CITY OF ALBUQUERQUE

RE: Lobo LL Field Expansion at Balduini Park
Grading Plan
Stamp Date: 7/13/17
Hydrology File: H16D149

Based upon the information provided in your submittal received 7/14/17, the Grading Plan **is not** approved for Grading Permit. The following comments need to be addressed for approval of the above referenced project:

LOBO LL FIELD EXPANSION AT BALDUINI PARK
GRADING PLAN

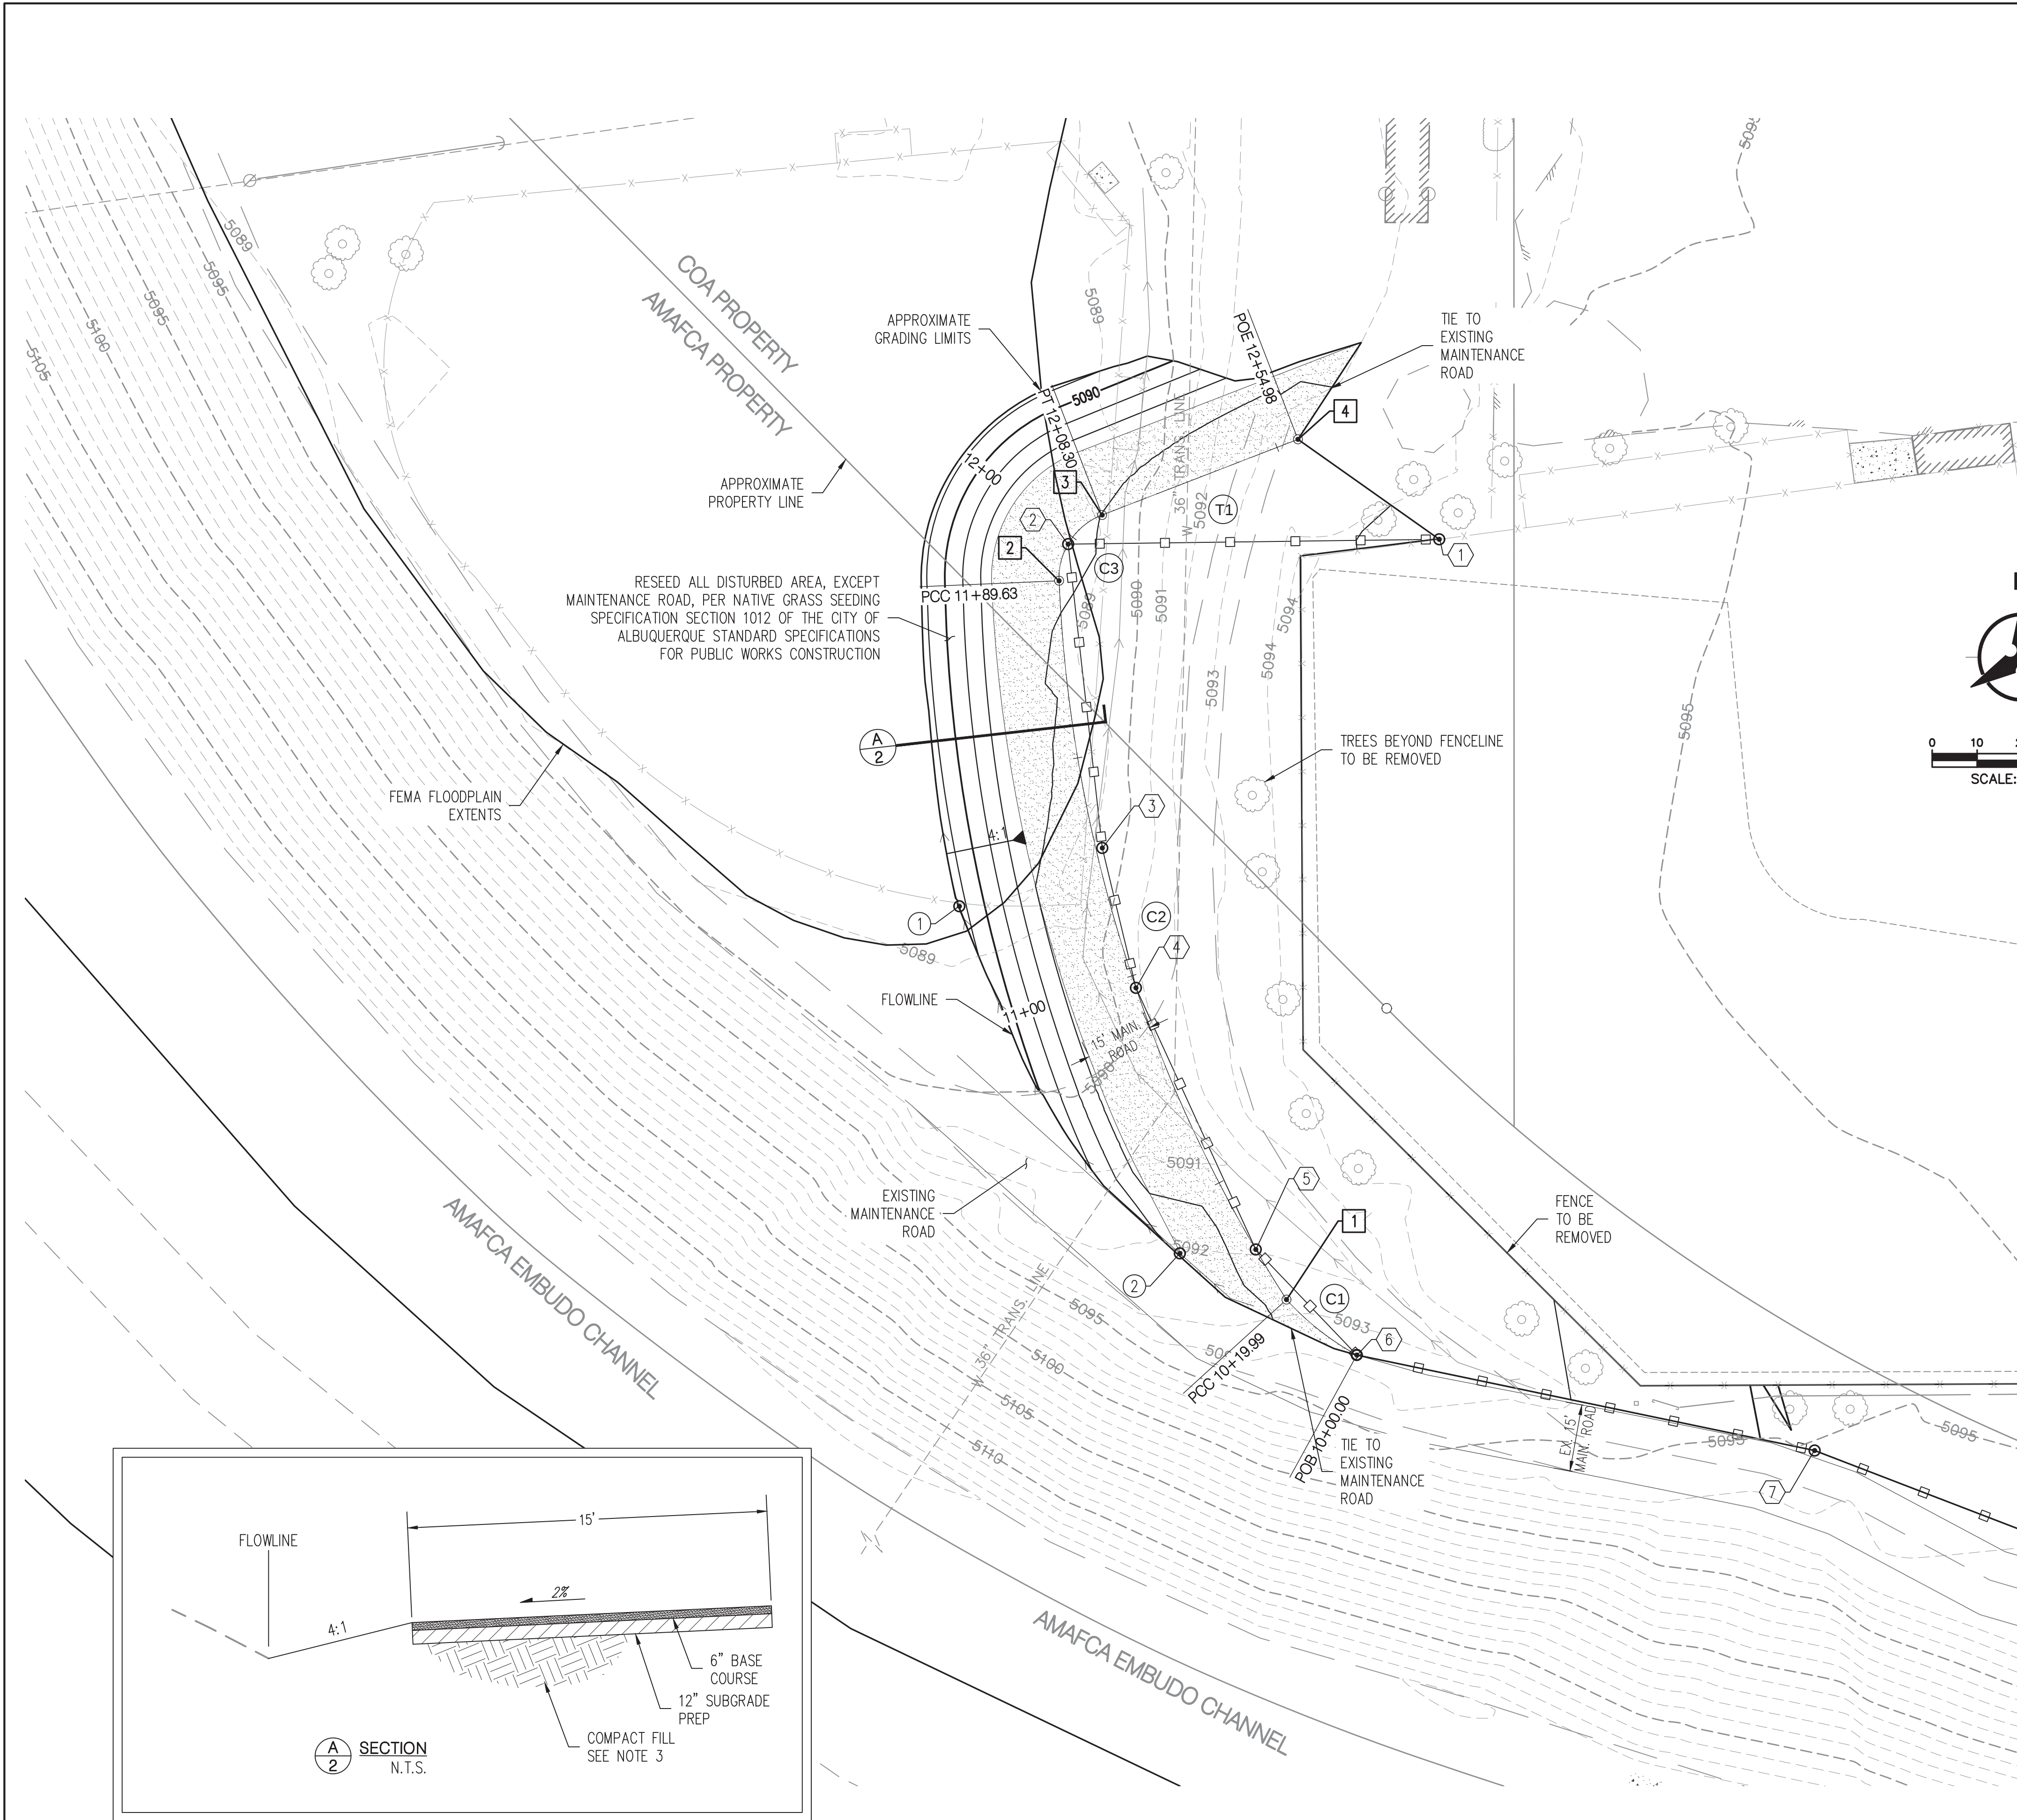
1. Since the work to be done lays partially on AMAFA property and the work to be done affects an existing AMAFA pond for Embudo Channel, approval by AMAFCA will be need prior to Hydrology approval. Please contact Bradley Bingham, PE at (505) 884-2215 or bbingham@amafca.org. Please provide an approval letter from AMAFCA in your resubmittal to Hydrology.
2. Please provide the floodplain note on the Grading Plan.
3. Please label and show the delineation of all floodplain zones within the Grading Plan. Please also include the 100 year flood information for Zone "AH".
